### Invitation for Bids No. IFB25-04

IFB Name: Lift Station Rehabilitation Project – Los Arboles and North Road

### Addendum No. 2

SHEET  
**2**

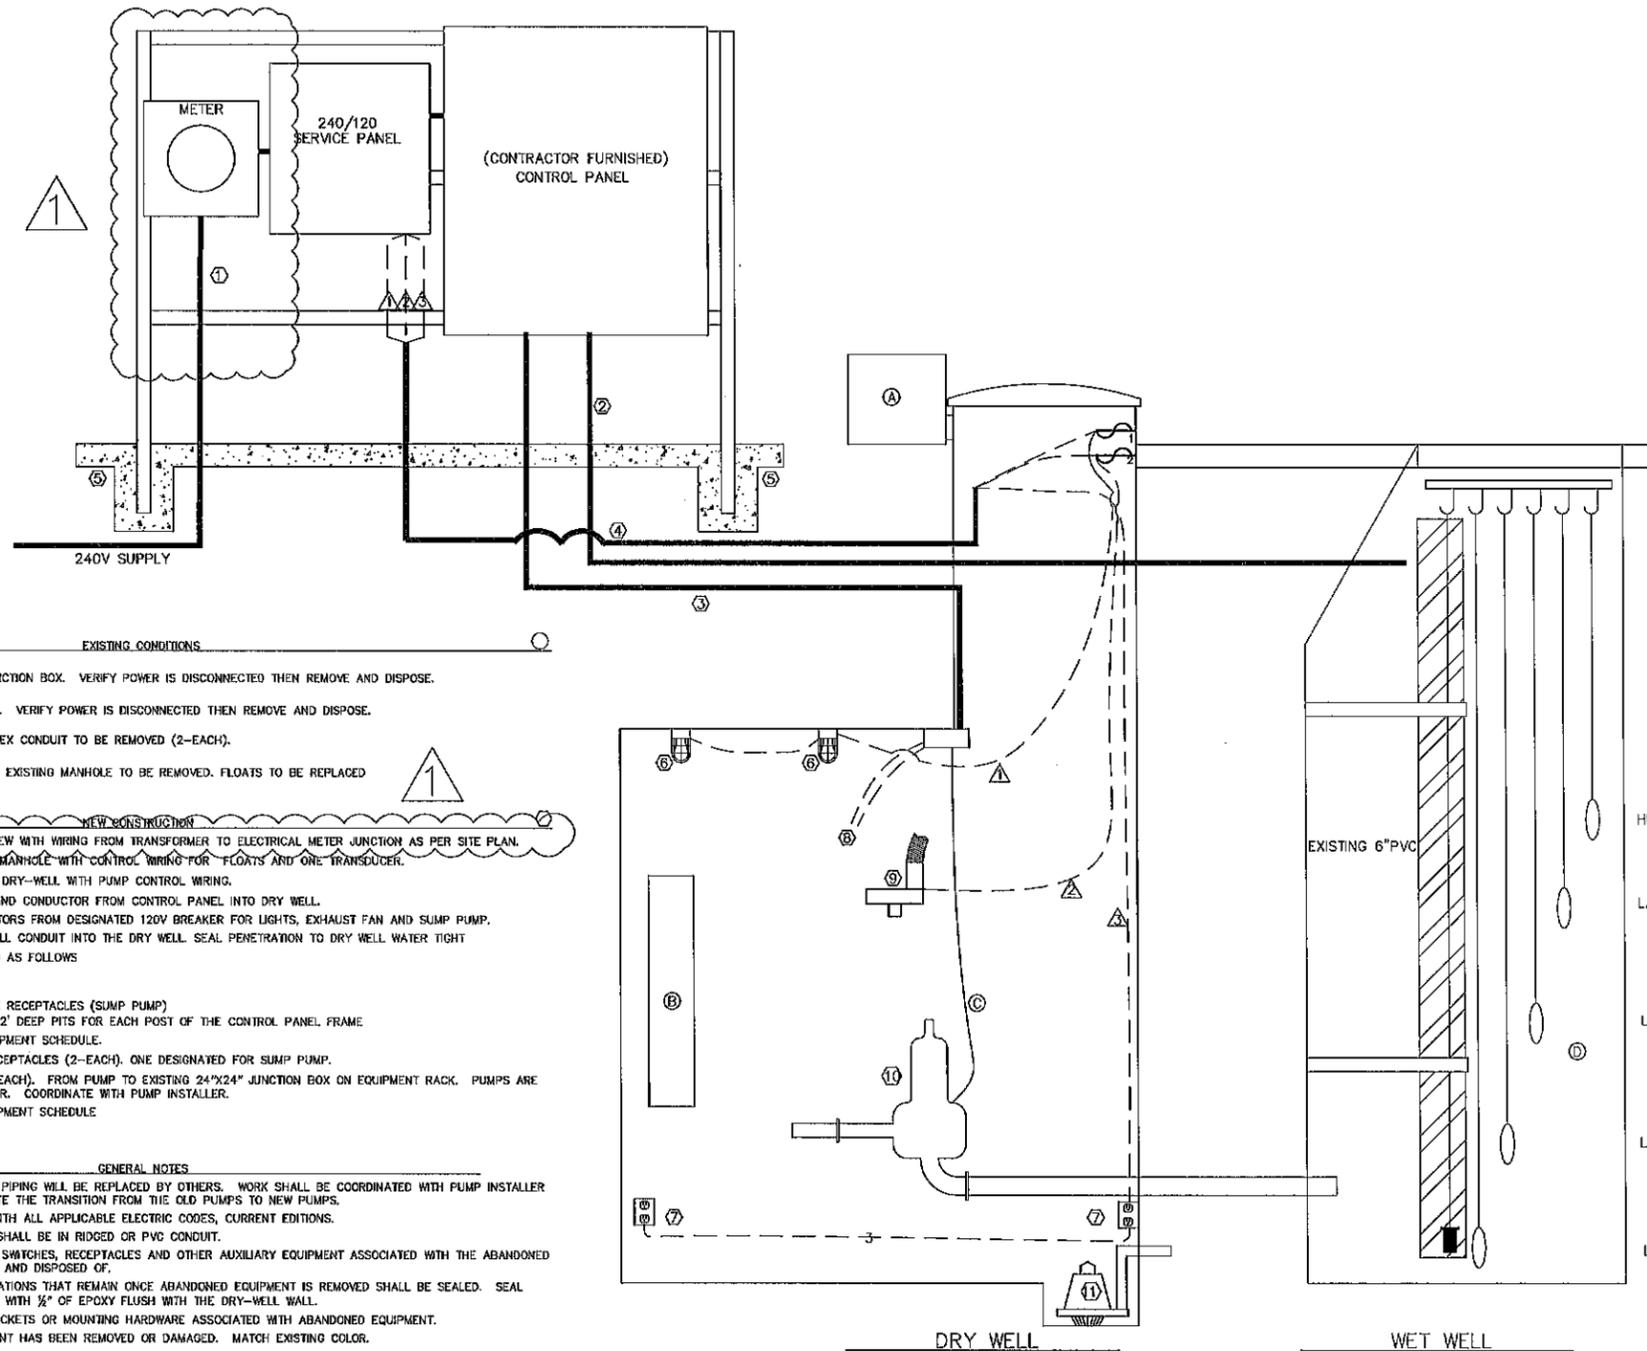
6) Note 8 on sheet 2 states for owner to provide wire and DPU to pull & term. We do not need to capture this wire correct?

**RESPONSE:** See revised note 8 on Sheet 2.

7. INSTALL CONCRETE PAD FOR NEW ELECTRICAL TRANSFORMER AS PER STANDARDS, TRANSFORMER BE INSTALLED BY DPU LINEMAN. REFER TO SHEET 2A FOR DETAILS
8. INSTALL 2-90FT 4" CONDUITS FROM TRANSFORMER TO NEW CONTROL PANEL AND NEW FLUSH BOX, AND 9FT 4" CONDUIT FROM EXISTING JBOX TO NEW TRANSFORMER. OWNER TO PROVIDE WIRING. DPU LINEMEN TO PULL THE CABLES ON PRIMARIES AND CONTRACTOR TO SECONDARIES. REFER TO SHEET 2A FOR DETAILS

SHEET  
3

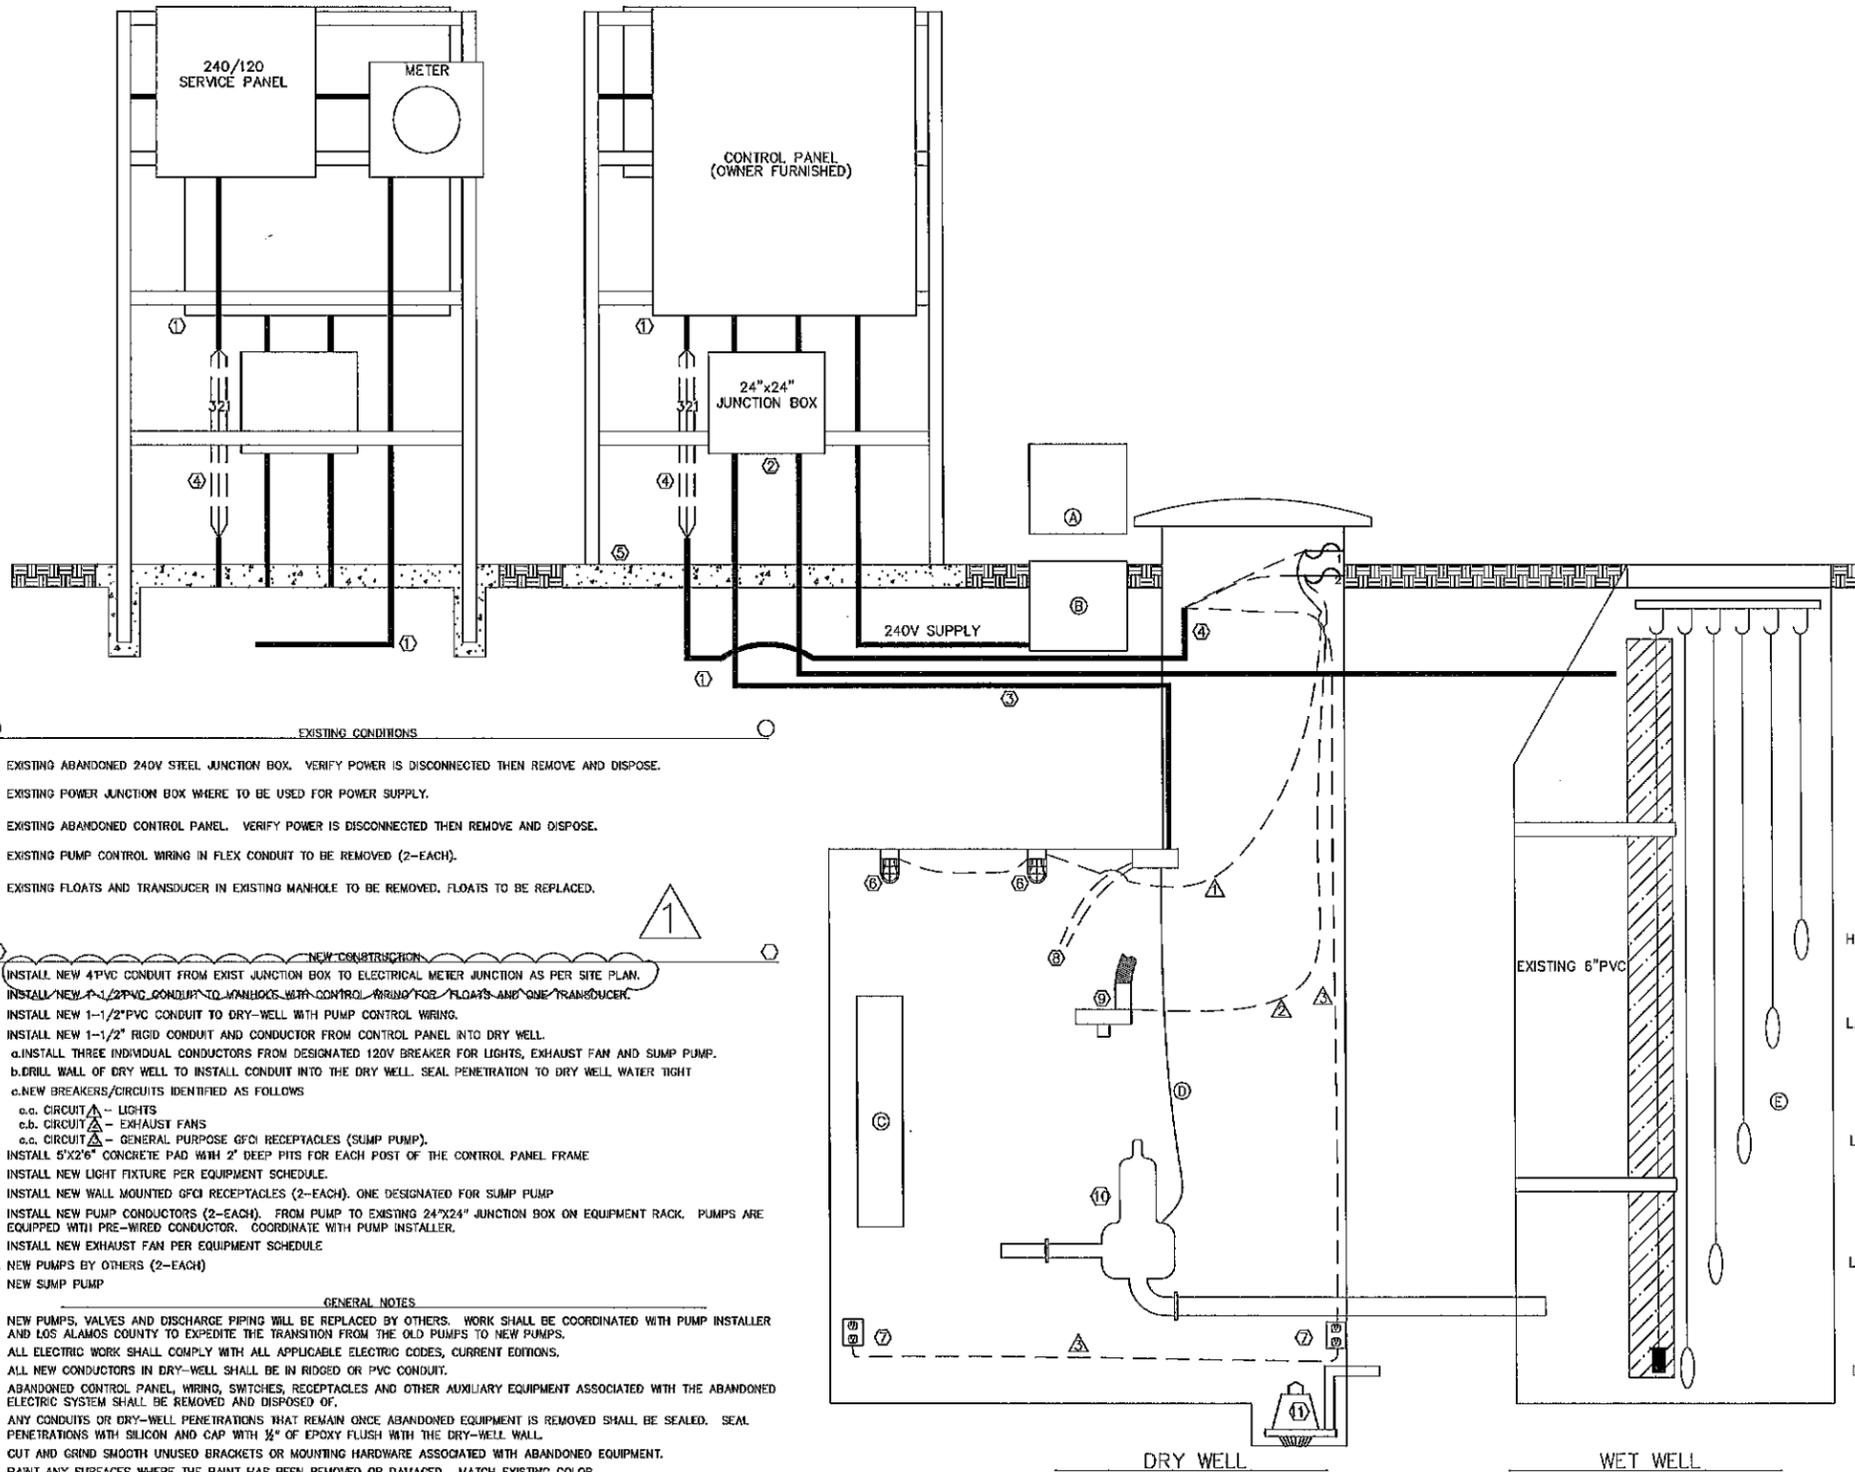
3) Sheet 3 “existing electrical” shows a control panel listed as “contractor furnished,” is the new Control Panel (CP) part of a pump package or does Contractor need to capture the control panel? Sheet 7 shows new CP as owner furnished. Please confirm.

**RESPONSE:** The CP for Los Arboles is contractor furnished, the CP for North Road is owner furnished and a part of the pump package.
